SITE PLAN REVIEW AND APPEARANCE BOARD STAFF REPORT			
3 <sup>rd</sup> & 3 <sup>rd</sup> Restaurant			
Meeting	File No.	Application Type	
January 25, 2023	2023-008-SPI-SPR-CL1	Class I Site Plan Modification	
Property Owner		Agent	
Chazmonti, LLC		Steve Siebert Architecture

Consideration of a Class I Site Plan Modification associated with a color change from seafoam green to Sherwin Williams Pure White SW7005 and the replacement of two windows to a sliding glass door and sliding glass window for the restaurant located at 301 NE 3<sup>rd</sup> Avenue.

Existing West Elevation (Google Maps)

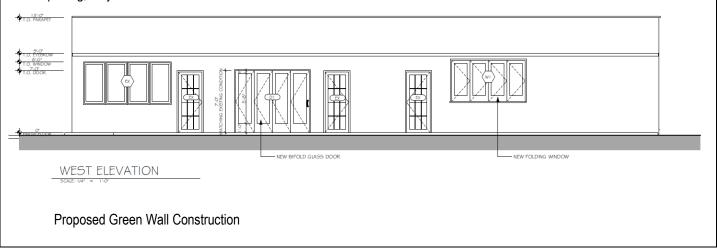
The request includes a color change seafoam green to Sherwin Williams Pure White SW7005. Two of the three existing window openings will be replaced; one with a sliding glass window system within the same opening and the other with a sliding glass door system. The opening that is being modified to accommodate the sliding doors, is maintaining the existing header, as well as the width of the opening; only the knee wall will be removed.

The proposed modifications can contribute to the image of the City, will not depreciate the appearance and value of the environment, and will be in harmony with the general area. The primary modification to install sliding doors where windows currently exist is consistent with modifications frequently found in restaurants that are able to take advantage of an indoor-outdoor atmosphere that is commonly desired by their patrons. Further, the modification provides additional ability to allow fresh air within the restaurant, whether permitting. The location within the Railroad Corridor Sub-district of the CBD requires review and compliance with the CBD standards.
